2020年8月11日  
アドバンテック株式会社

## PCI ExpressライザーカードSOM-EA10変更のお知らせ

<b>Key Information &amp; Milestones:</b> ECOM number: <b>ECOM-160800</b> ECOM released date: <b>April 10<sup>th</sup>, 2020</b> Last Time Buy date: N/A

**Comparison between 9696EA1000E (A101-2) & 9696EA1010E (A201-1)**

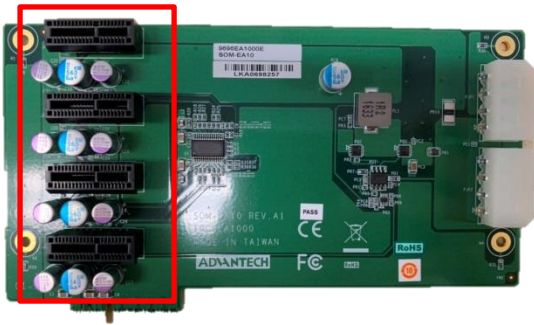
<b>Description of Change:</b> Product enhancement. Update PCIe Riser Card SOM-EA10 from PCIe Gen2 to PCIe Gen3	
<b>Affected Product Model No.:</b> SOM-DB5830 product series SOM-DB5920 product series	
Original P/N	Replacement P/N
<b>1. 9696EA1000E</b> SOM-DB5830-00A1 SOM-DB5920-00A1 SOM-DB5920-F0A1	<b>1. 9696EA1010E</b> SOM-DB5830-00A1 SOM-DB5920-00A1 SOM-DB5920-F0A1
<b>Potential impacts to customers:</b> PCB: Change to 9696EA1010E (A201-1) BIOS: no change required EC Firmware: no change required OS: no change required Driver: no change required	
<b>Ordering Information:</b> No Change	
<b>Impact of change &amp; recommended action date:</b> SOM-EA10 4ports PCIe x1 Riser Card will upgrade from <b>9696EA1000E</b> to <b>9696EA1010E</b> after <b>ECOM-160800</b> implemented on April. 10 <sup>th</sup> , 2020. 1. PCIe Riser Card SOM-EA10 included in SOM-DB5830-00A1/ SOM-DB5920-00A1/ SOM-DB5920-F0A1 will be upgraded to <b>9696EA1010E</b> to support PCIe gen3 bandwidth up to 8 GT/s transfer rate. 2. No functions are changed and all functions are backward compatible.
